STORM DRAINAGE STUDY
RELATIVE TO DEVELOPMENT OF LOT 208
UNIT 6, TOWN OF ATRISCO
ALBUQUERQUE, NEW MEXICO

Re: Storm Drainage Study
Lot 208, Unit 6
Town of Atrisco

Job Granada View - Lot 208 Sheet No. R-1 of
 Subject Drainage Study Job No.
 Client Tyree Surveying By JPC Date 8/75
 MAC CORNACK & BURNS Consulting Engineers, Inc., Albuquerque, NM

TYREE SURVEYING COMPANY			
201 EUBANK N.E. ALBUQUERQUE, NEW MEXICO			
GRANADA VIEW			
GRADING PLAN			
DATE: 8/75	SCALE: 1" = 50'	DRAWN: A.D.W.	SHEET 1
		CHECKED: R.E.T.	OF 1

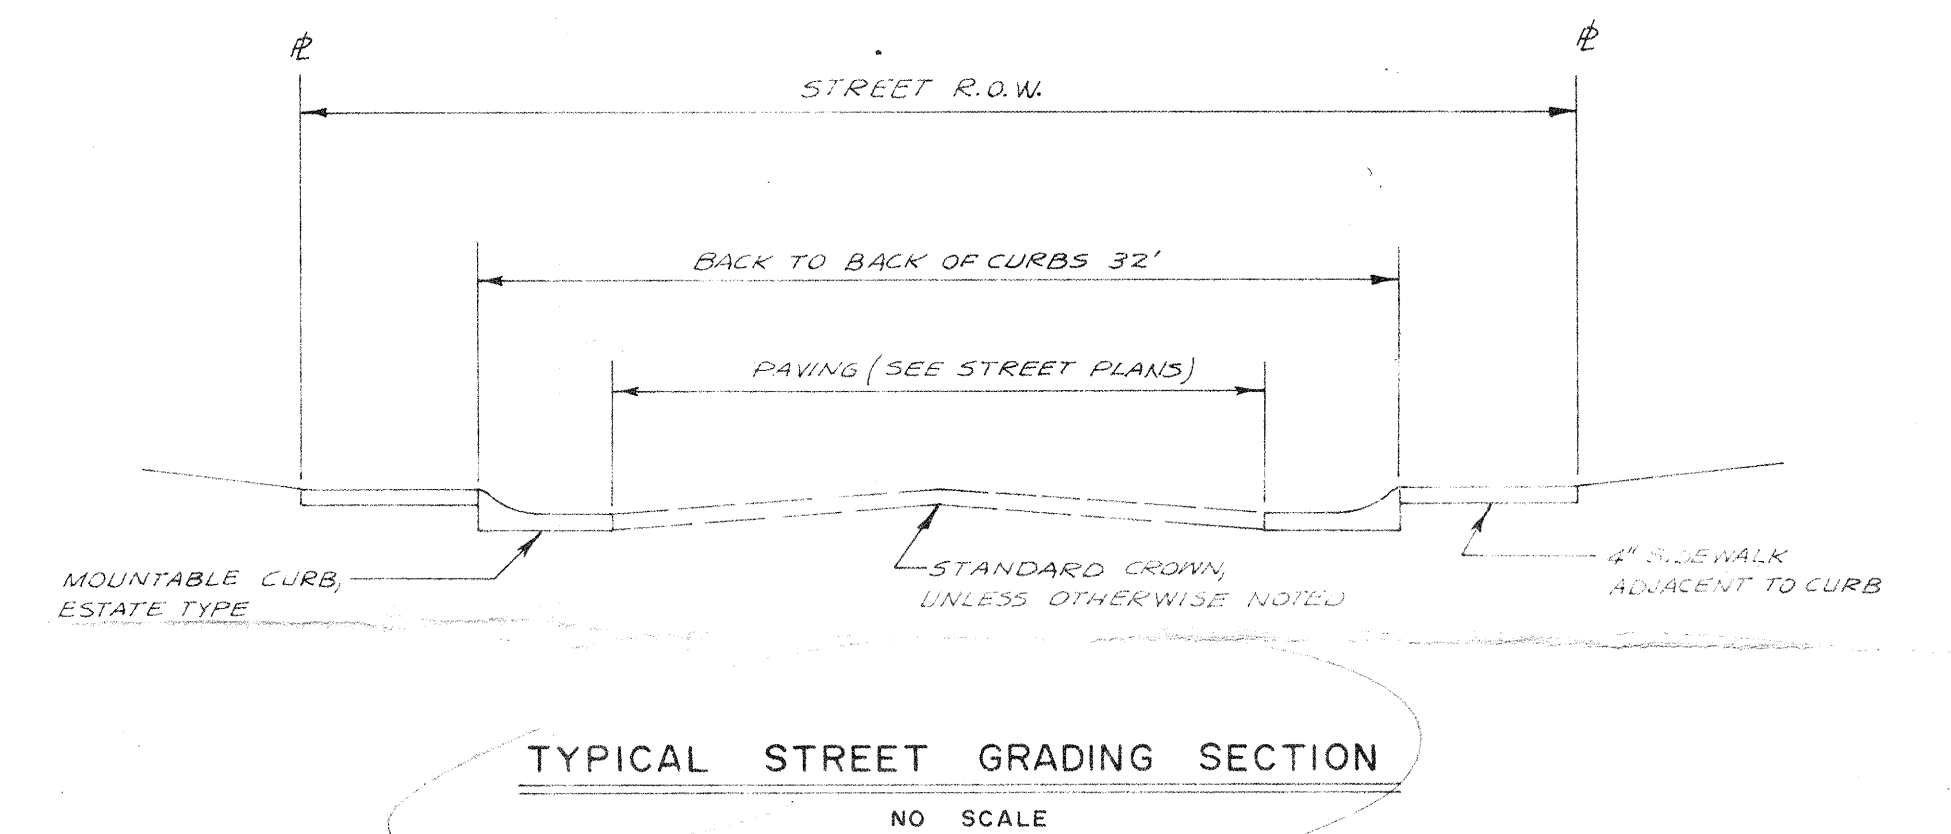
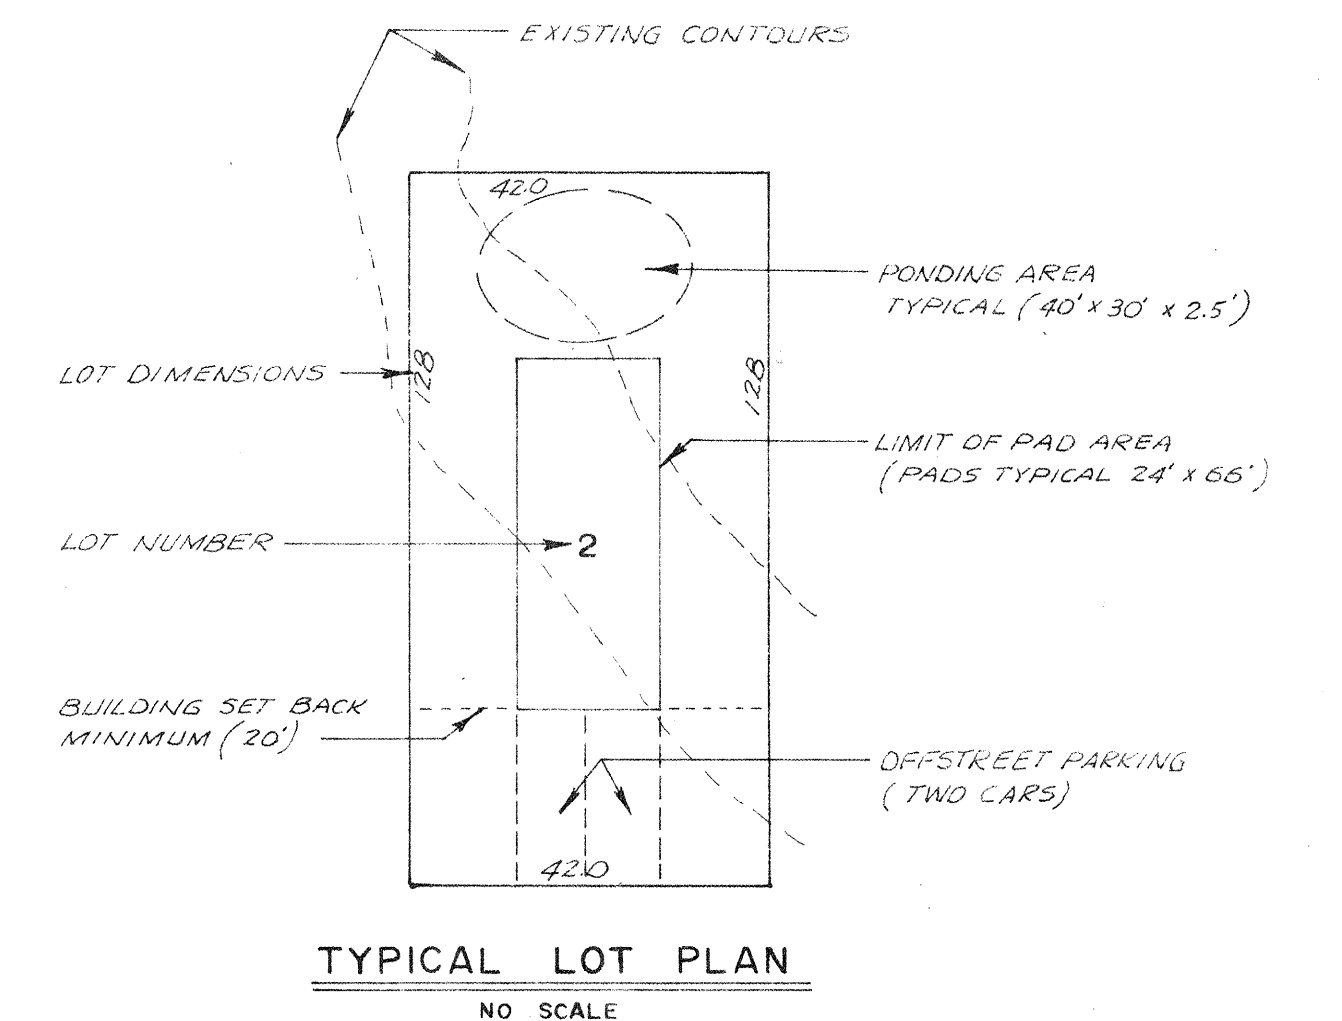
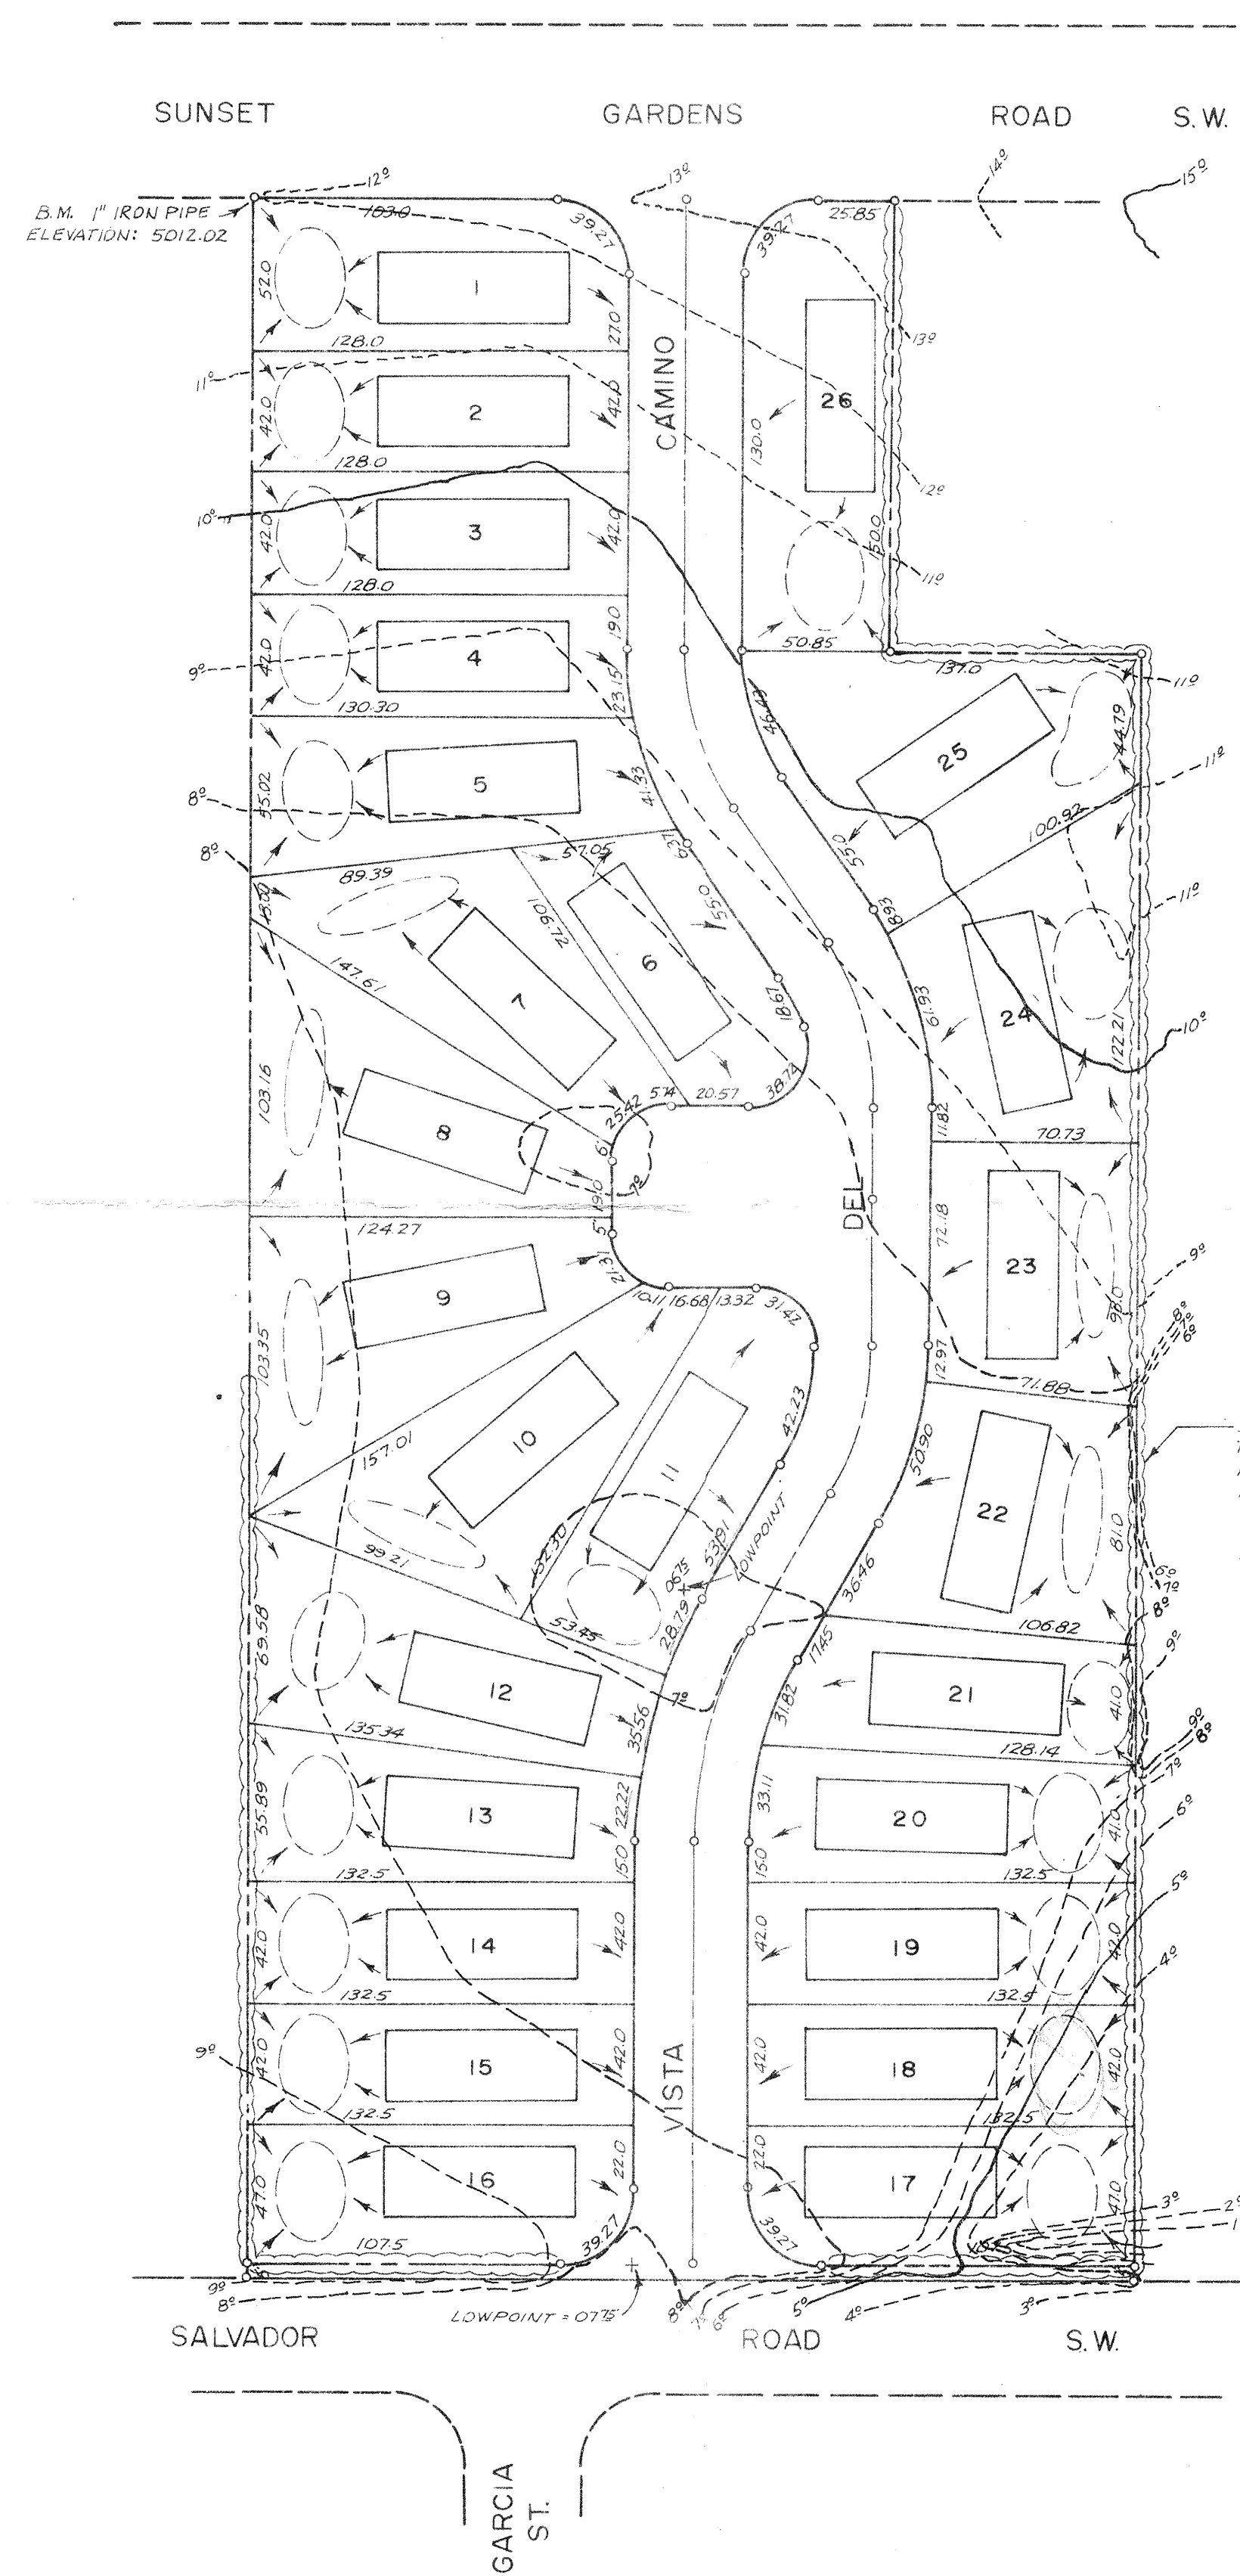
> 4.3 OK.
how will you drive across?

Attached is the revised Drainage Plan drawing incorporating your typical street section. Drainage capacity of the revised section is approximately 37 cfs at a slope of 0.0025.

Also included are revisions to the final grading plan which will insure flow from trailer roofs and driveways to the planned ponding areas. Typical ponds are to be forty (40) by thirty (30) feet with a maximum depth of 2.5 inches.
